Remarks:

This Amendment is directed to the Office Action mailed on December 1, 2004 setting a three month shortened period for response expiring on March 1, 2005. Claims 1,14, 16-18, 20-29, 32-36 stand rejected. Claims 15, 19, 30 and 31 stand objected to as containing allowable subject matter but depending from rejected base claims. Claims 1, Reconsideration is requested in view of the above amendments and these remarks.

FIG.7

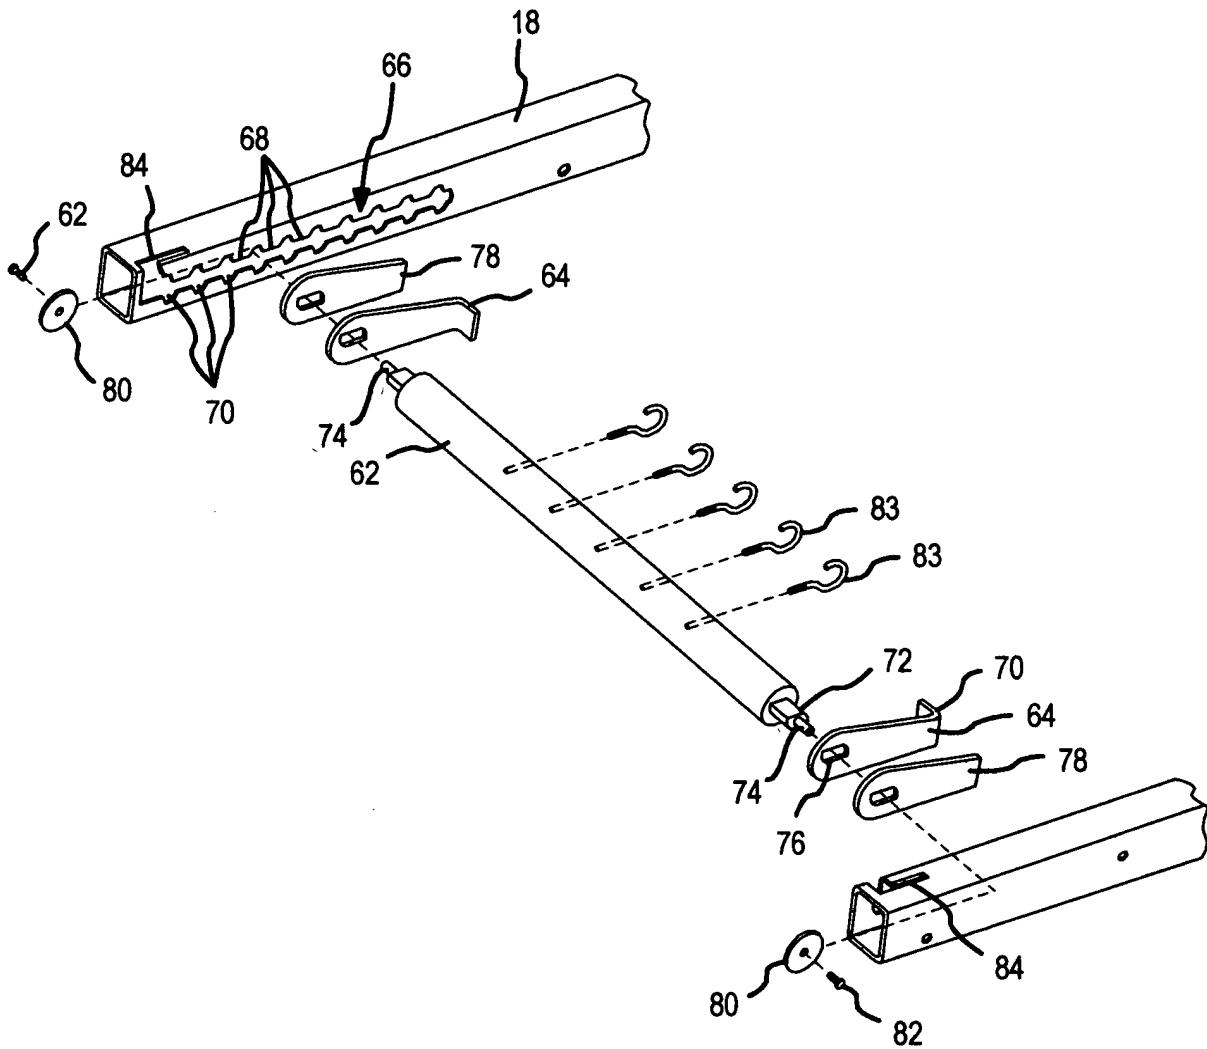
The drawings are objected to as a reference numeral 74 recited in the specification is not provided. The specification is also objected to for several informalities. Fig. 7 has been amended to provide the missing reference numeral 74. A markup of Fig. 7 is also provided in the Appendix to this Amendment with the new numeral 74 highlighted.

Please replace Sheet 7 of the drawing with the attached Replacement Sheet 7. A markup of Sheet 7 showing the drawing changes is included with this amendment in the Appendix.
